Eastern Area Planning Committee

Wednesday, 7th February, 2018 at 6.00 pm

UPDATE REPORT

Item No: (1) **Application No:** 17/03079/COMIND **Page No.** 25 - 41

4. Access to the allotments

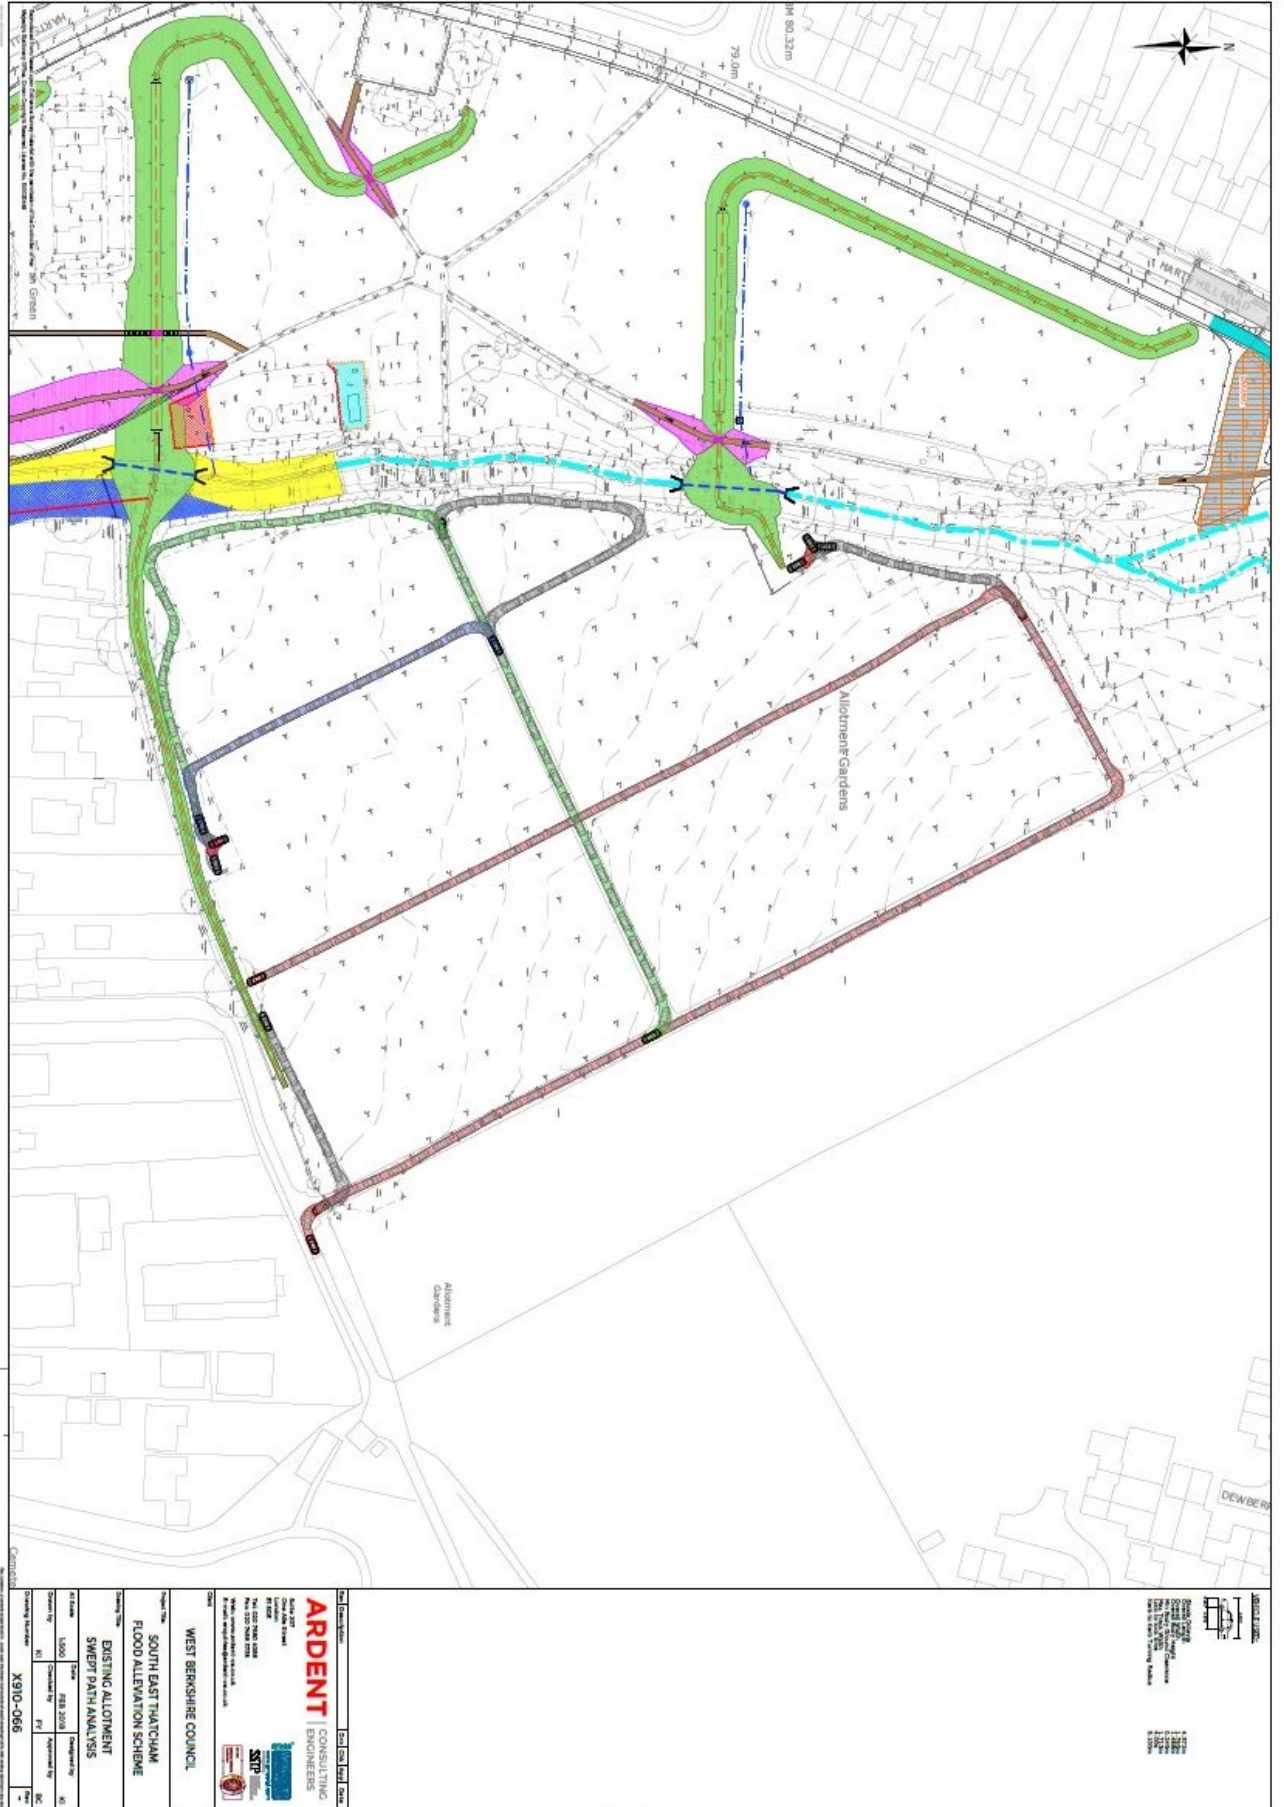
The lead flood authority has provided a swept paths diagram (attached) demonstrating that the bunding to the north west of the allotments would result in only a small amount of allotment land, this forming part of the track providing vehicular access, and not land in use as an allotment plot would be taken up by the bund. The swept paths diagram has demonstrated that this would not prevent vehicular access to the allotment plots. As such your officer considers that an alternative solution involving the creation of a ramp over the bund would be unnecessary and would further result in the loss of additional trees from alongside the allotments.

During the site visit Members also queried whether the bund alongside the southern access track to the allotments would interfere with vehicular access in that location. The swept paths diagram demonstrates that the bund will intrude slightly on the access, encroaching over a 15 metre stretch of the access track, but that the allotment layout will still allow sufficient space for vehicles to gain access to the existing roads within the site. The proposed works are therefore not considered by your officer to prevent access for users to the allotment plots, albeit that they will result in alterations to the existing vehicular routes through the allotments.

drawing: Tree Protection Plan

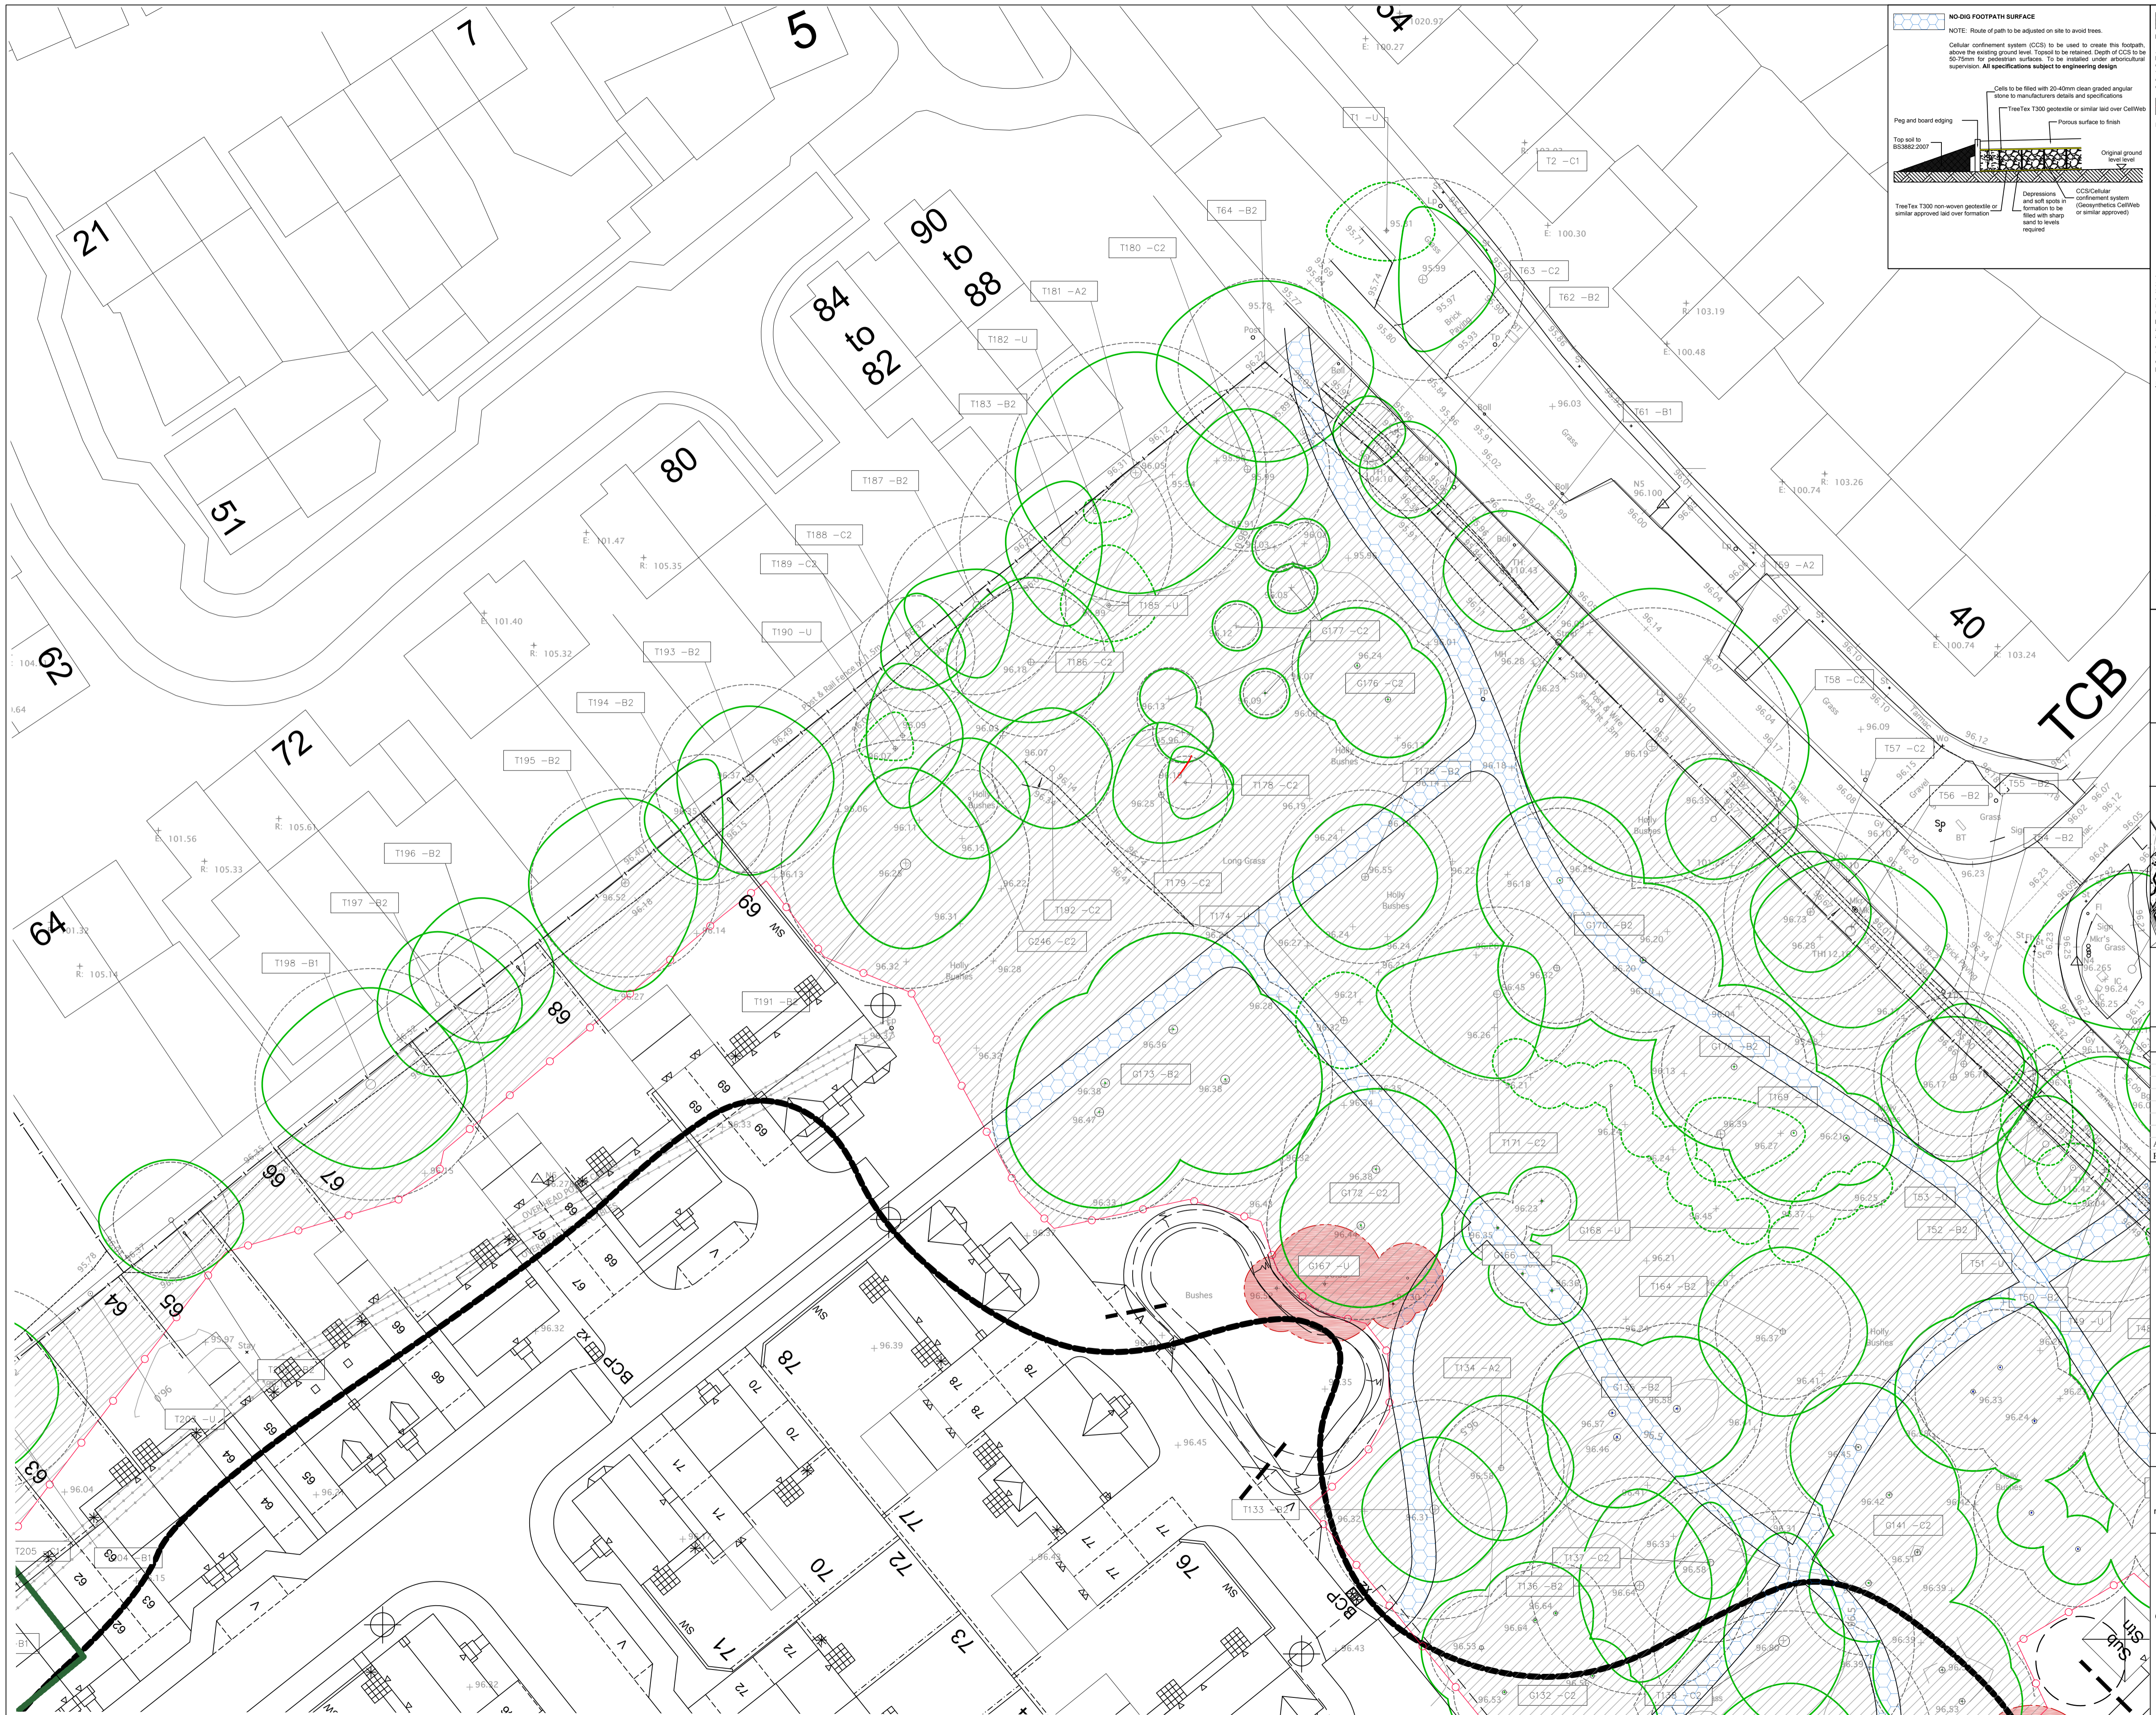
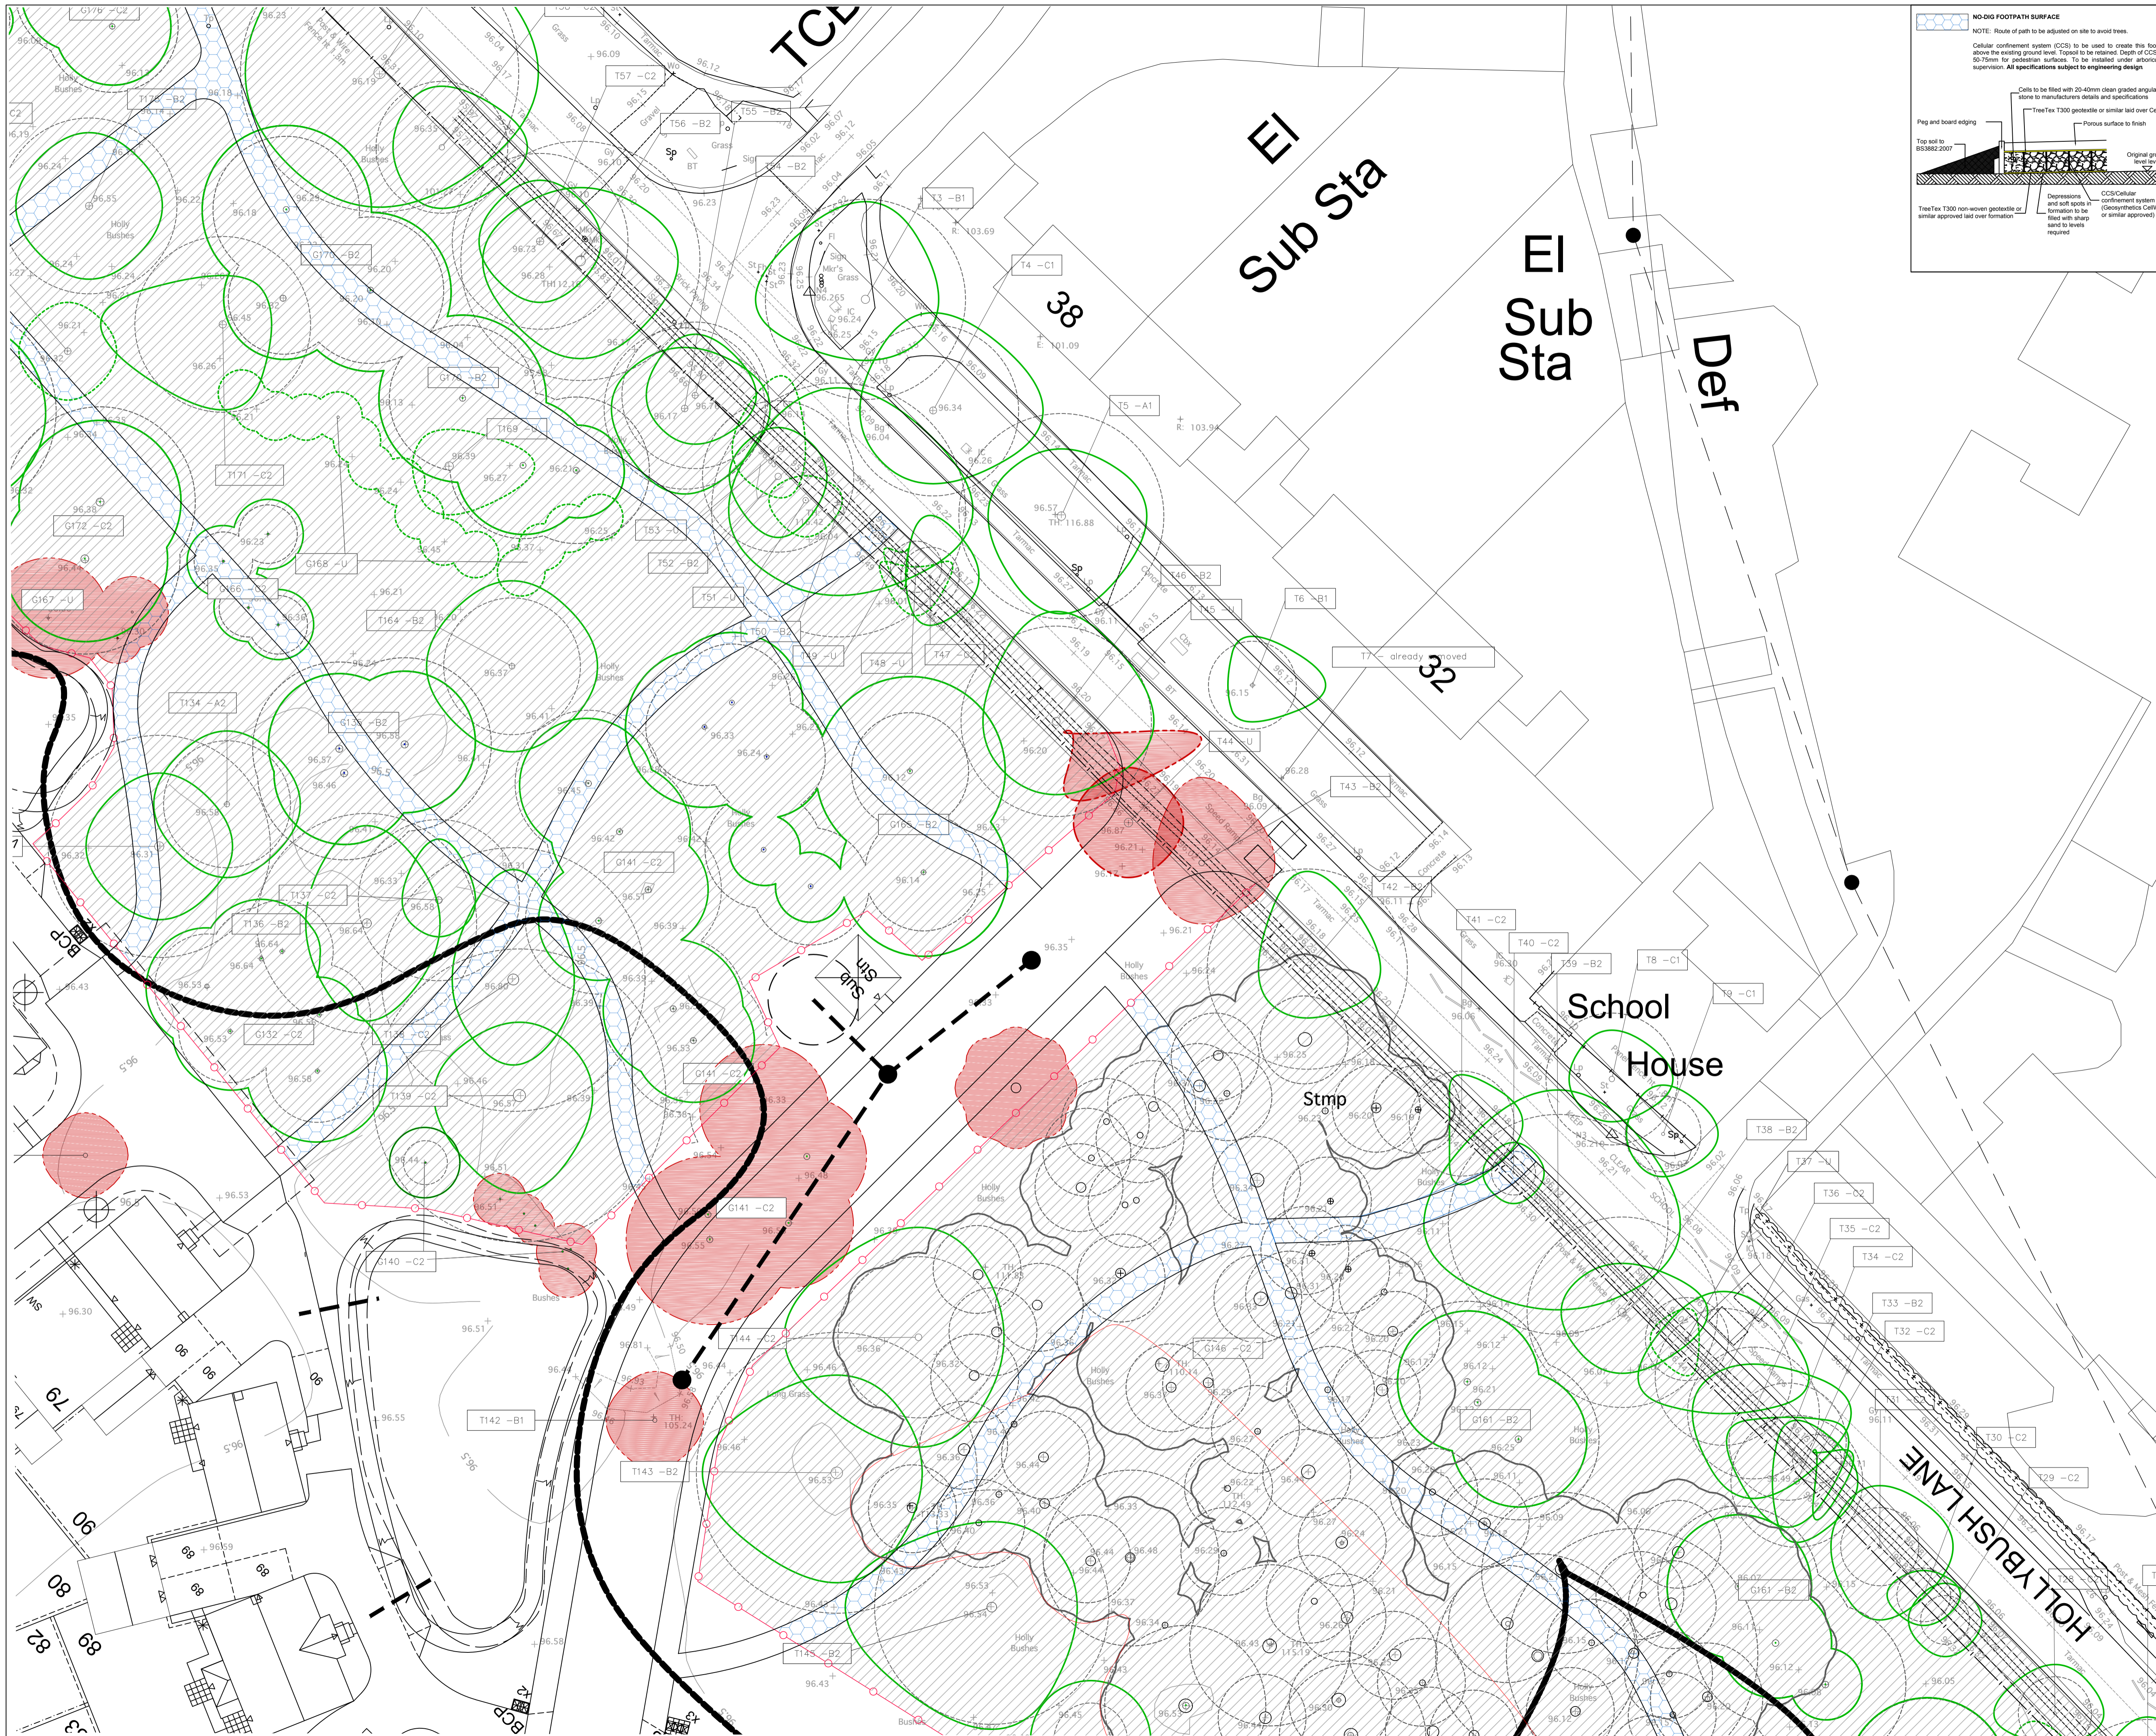
The approved drawings are attached showing the trees to be removed in red.
